SAM D10 Series Family Silicon Errata and Data Sheet Clarification

Data Sheet Clarifications

FIGURE 34-3: BOD33 HYSTERESIS OFF

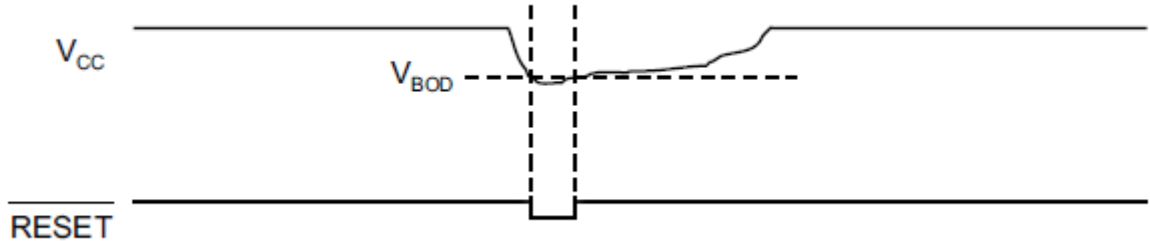
Figures 34-3 and 34-4 have an incorrect reset Polarity value. The correct figures are displayed as follows:
